City of Oxford
Community Development Department
STAFF REPORT

Board of Zoning Appeals

Case # BZA-12-2008

Petitioner:	Tri-State Signs Unlimited
Location:	5640 College Corner Pike
Owner:	JWL Oxford LLC
Action Request:	Variances to Sections 1151.05(A)(3) permanent signs
Current Use:	Commercial Store “Maurices”
Zoning:	“GB” General Business
Surrounding Land Uses:	Commercial

EXTERIOR / FACE LIT INDIVIDUAL CHANNEL LETTERS
24" Set Remote Wired BLUE FACE

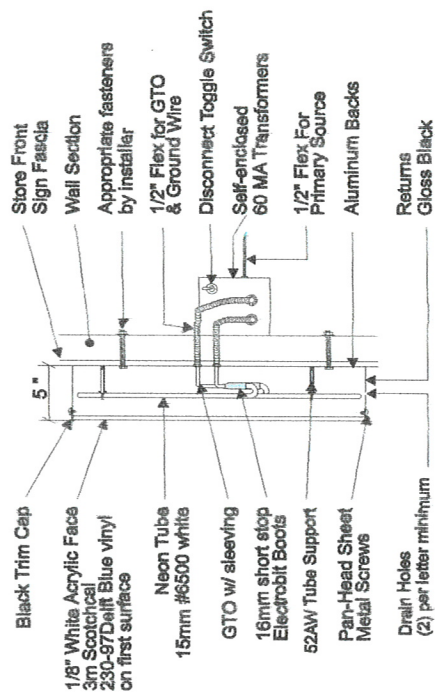
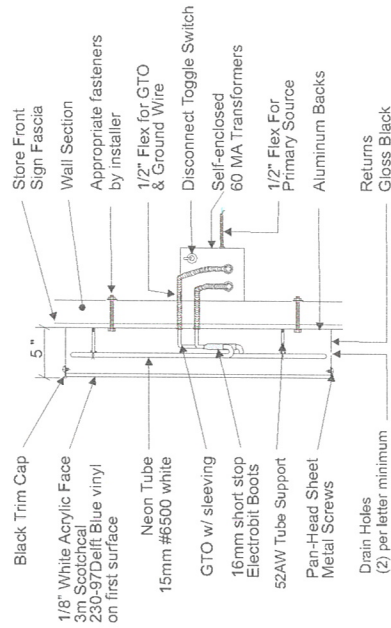
This application is seeking an additional sign to be placed at the back of the building of this multi tenant strip center. Staff struggled with the decision standards to adequately consider the arguments made by the Applicant. The argument made by the Applicant is the difficulty for delivery truck to locate the store during regular hours. This would be the same for any tenant of this building. Staff struggled with the uniqueness of the site and special privilege criteria outlined in the decision standards. Staff does not feel that the application meet the decision standard ((B), (D) (E).

Staff can not discern the application has met the decision standards. Should the BZA recommend approval, Staff recommends the following conditions:

HELPS IDENTIFY THE BUSINESS LOCATION. THIS SIGN DOES NOT
APPEAR TO BE INAPPROPRIATE ON SIZE + LOCATION.
ACE HARDWARE HAS A SIMILAR SIGN ON THE BACK OF THE BUILDING

1. That, the sign to be turned off at the closing of the store,
2. That, the proposed work be constructed as approved with this appeal and that no changes or modifications be made without the consent of this Board.

SITE PLAN
1" = 20'-0"
SHOWING ADDITION OF 2-STORY DUELLING UNIT TO AN
EXISTING SINGLE FAMILY RESIDENCE. CREATING A
2-FAMILY RESIDENCE IN THE R2MS ZONING DISTRICT
SURVEY INFORMATION FROM: BAYER BECKER
EXISTING SITE PLAN OF 210 SOUTH POPLAR, LOT #39
9/05/08

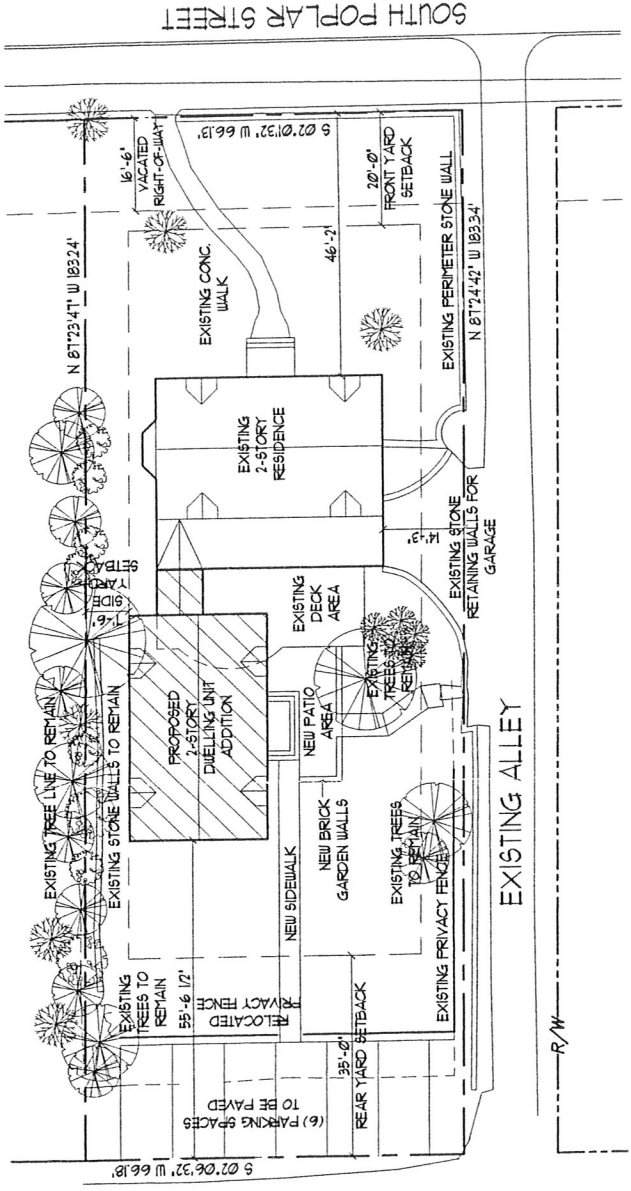
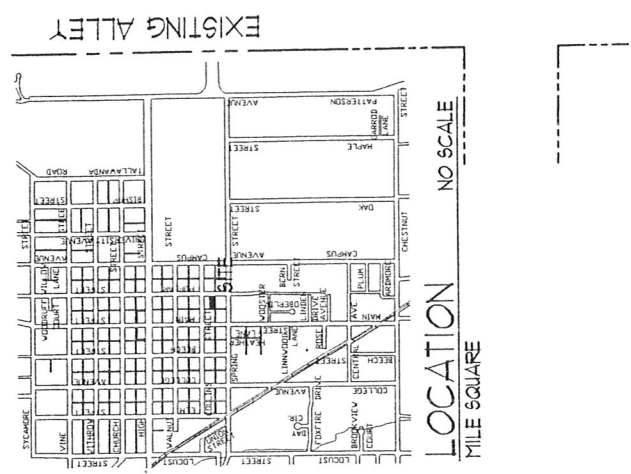
Staff also indicated to the Applicant that existing landscape timbers and landscaping material on the east-west alley should not be in the right-of-way and need to be removed.

- The submitted site plan was not prepared by an Ohio licensed surveyor, as required.
- We are aware of the parking requirements; however, we must realize the present parking conditions in the area of the proposed structure, and the additional parking required by the proposed additional tenants. Simply put, on street (alley) parking in the area is almost non-existent.

1. That, the proposed work complies in all other respects with all applicable codes, Ordinances and the City of Oxford Zoning Code.
2. That, the proposed work be constructed as approved with this appeal and that no changes or modifications be made without the consent of this Board.
